Access Compliance Report Public Rights-of-Way (Pedestrian Signals)

Main Street: GILBERT_ST Cross Street: KATELLA_AVE Location: W

ADA ID: SGRK210916133536 Signal Type: One Push Button-Non APS Overall Compliance: No Severity Scores: BTN 1: 25 BTN 2: N/A No BTN: N/A

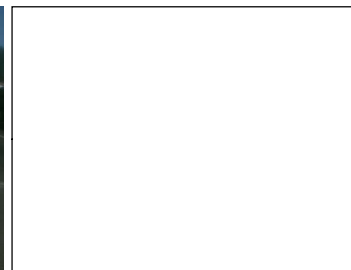
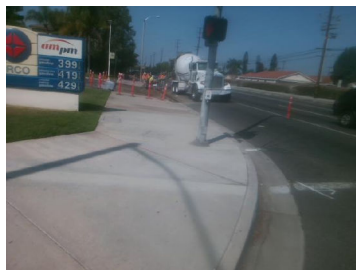
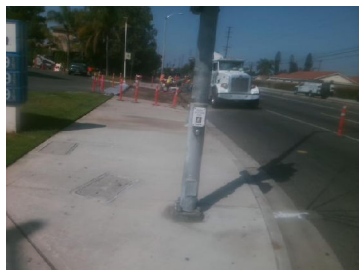
OC Std/PROW: MUTCD 4e.08, R404.3, R404.2

Possible Solutions: Replace Signal Push Button With APS Button. Remove & Relocate Sign.
